Agenda
Planning Commission
Wednesday, 20 February 2019 – 7:00 P.M.
City Hall – Council Chambers, 1 S Huron St
Ypsilanti, MI 48197

**Staff Review of Site Plan Application
Cultivate Coffee & Tap House
307 N River**

Application Date: 16 March 2018
Revised Plans dated **19 October 2018**
ZBA review 23 Jan 2019

SHEET
Site Plan

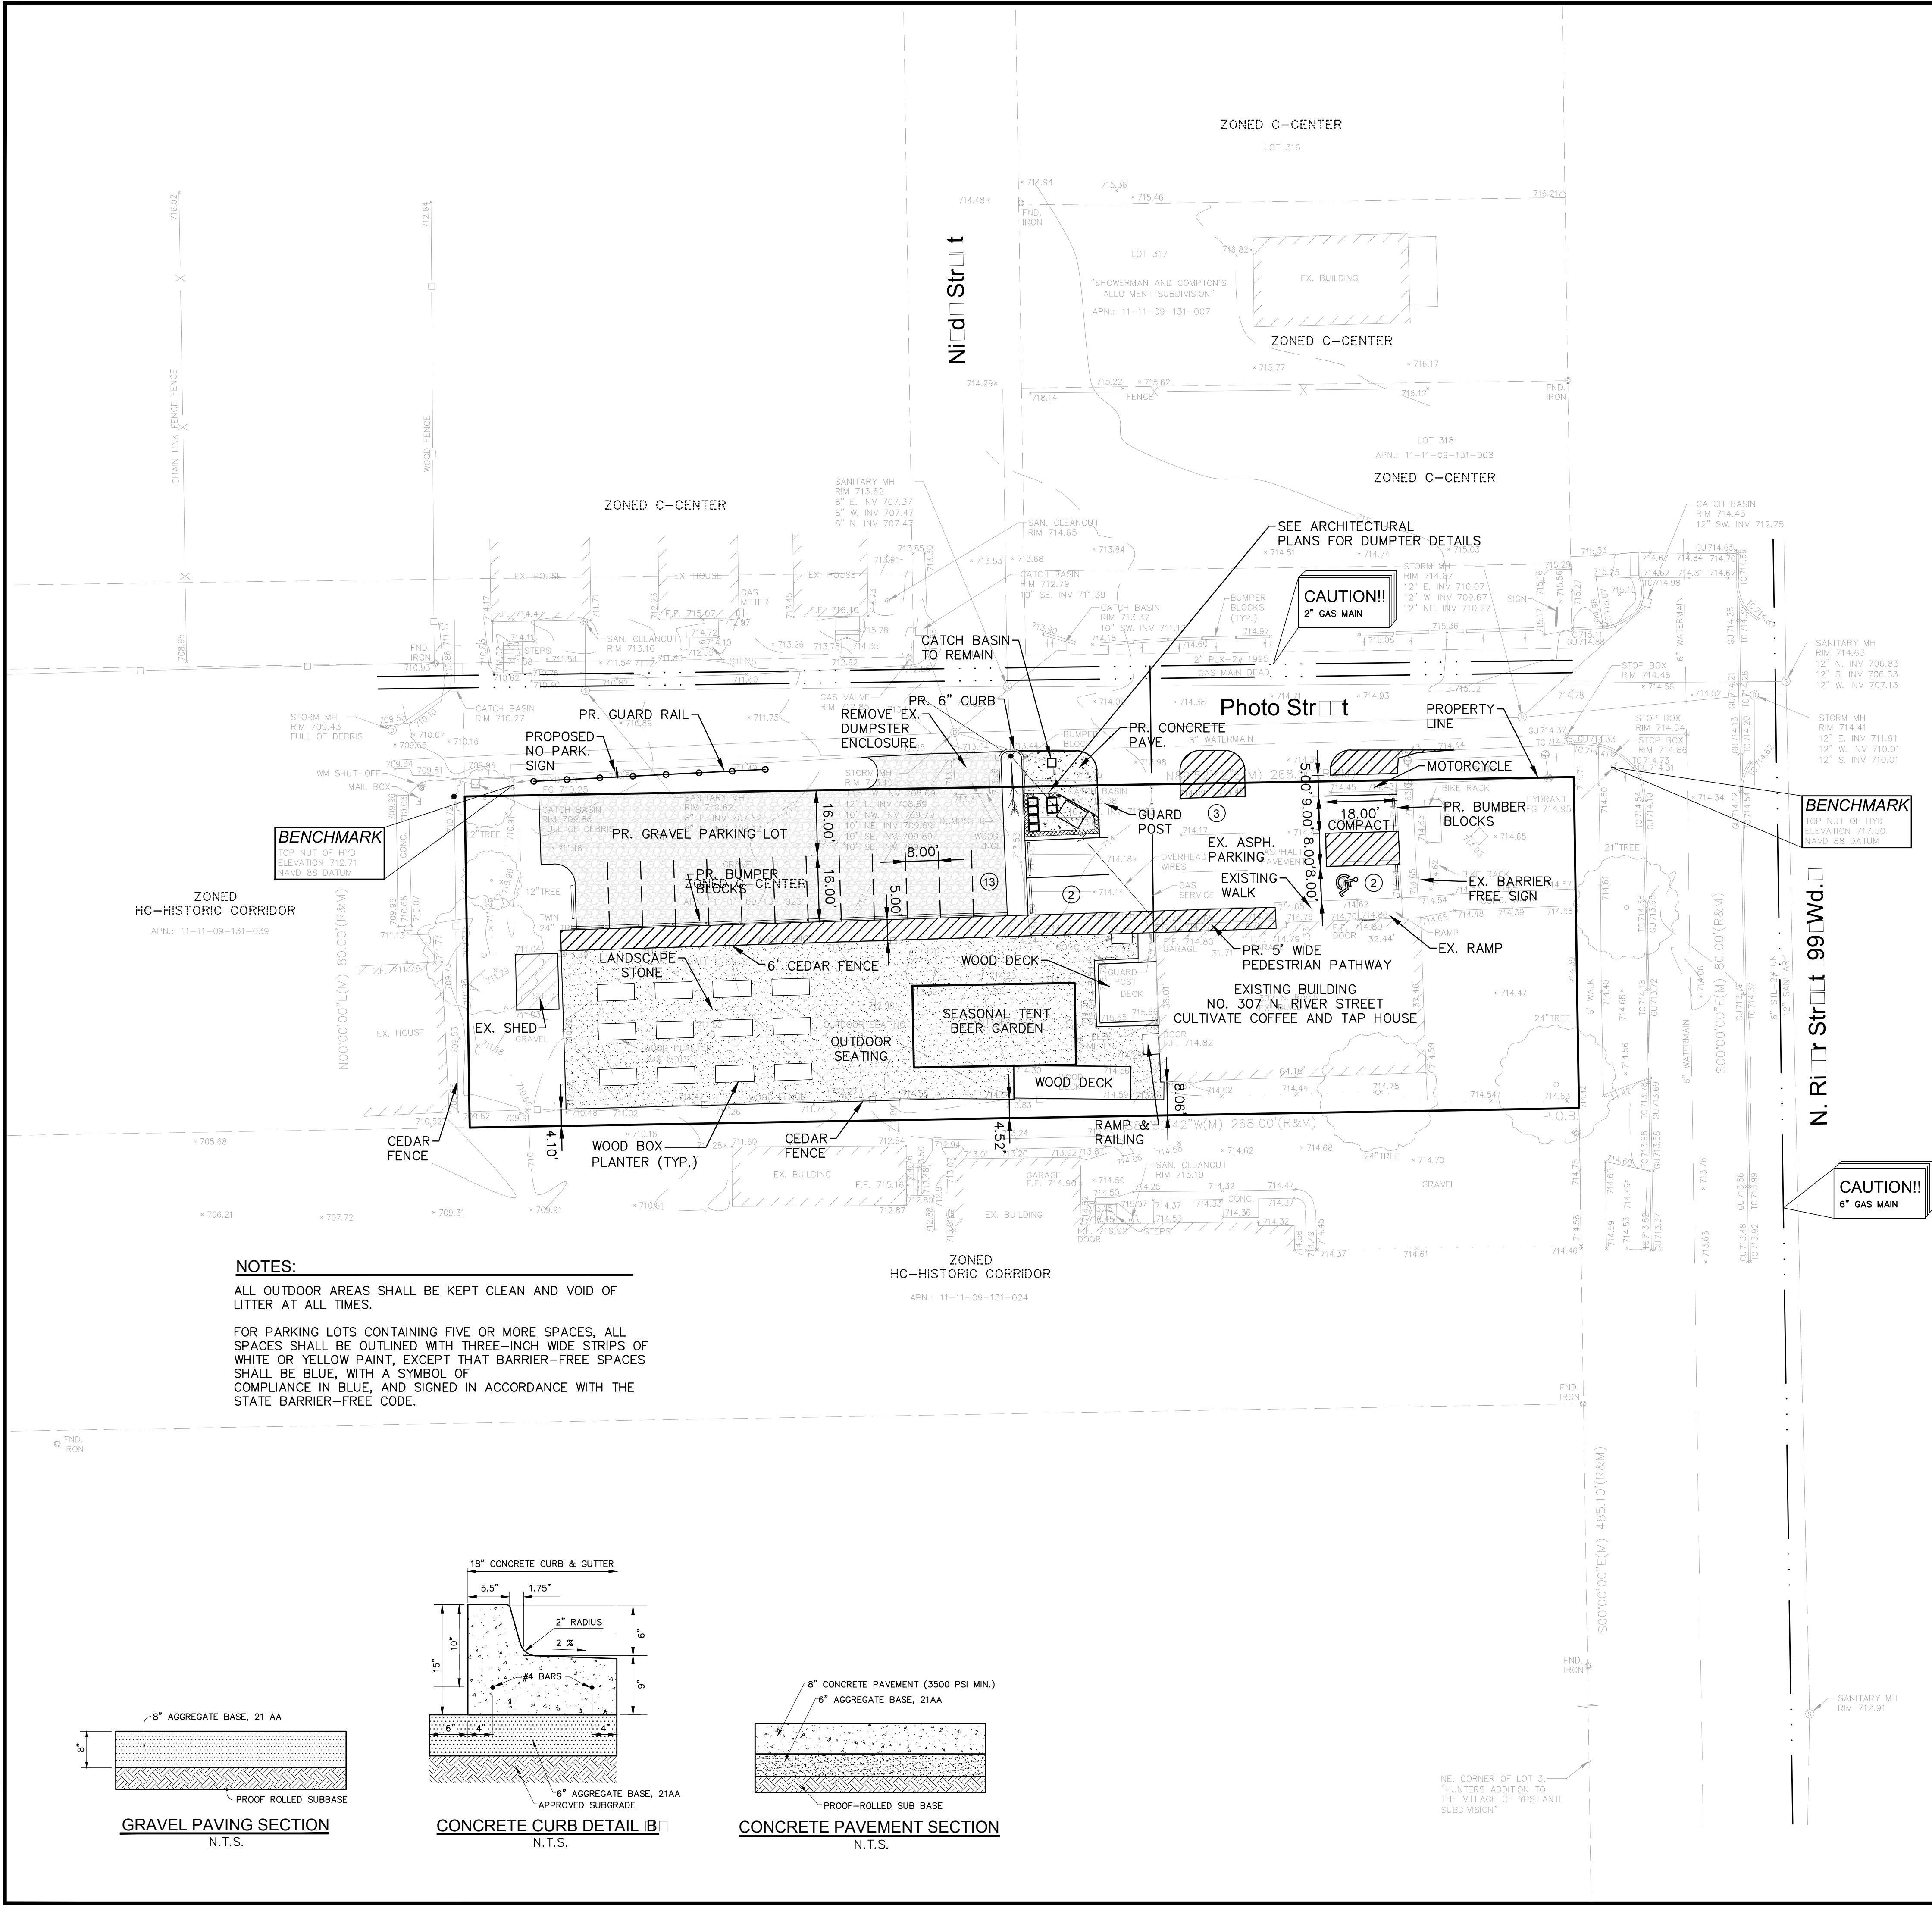
- Street Side yard parking is not permitted for this building type. Previous reports inaccurately designated the Building Type as "Single Story Commercial" due to the type of building located on it. Building types are dictated by lot size and dimensions, not the existing building.
- Shed height is not shown on the site plan. Please show the shed height.

- The parking aisle entrances off Photo to the paved parking area are misaligned with the Sidetrack parking area entrance.
- Two trees to satisfy the "internal" parking lot landscaping requirement are required. Planning Commission may choose to count trees provided elsewhere for this tree requirement.
- The "landscaped island" between the paved and unpaved areas does not meet minimum size guidelines.
- Parking aisles in paved area are not provided with landscaped islands (either raised/curbed or stormwater control) on the Photo side.
- Paved parking area is not screened from Photo.
- Pedestrian walkway is not protected from encroachment in paved parking area.
- The maneuvering aisle provided for the gravel parking area is 16' of a required 22' (bidirectional traffic).
- No sidewalk provided along Photo.
- Traffic visibility ordinance is not met.

- Provide further detail on existing building-mounted light(s) providing light intended to light paved parking area and any lighting serving the outdoor assembly area.
- Placement of dumpster in street side yard requires a PC waiver with a finding that no other location is possible.
- Applicant to provide further landscape detail during next phase of review.
- Applicant to extend conflicting land use buffer on west side of site southward to screen shed entrance/pedestrian walkway.
- Applicant has provided an insufficient number of street trees per 122-636 (2 of 12 required). Applicant to request PC waiver per 122-636 and provide fee-in-lieu or additional trees in alternate locations, or to provide the required number of trees.

- Shed height is not shown on the site plan. Please show the shed height.
- Provide further detail on existing building-mounted light(s) providing light intended to light paved parking area and any lighting serving the outdoor assembly area.
- Applicant to provide further landscape detail.
- Applicant to extend conflicting land use buffer on west side of site southward to screen shed entrance/pedestrian walkway.
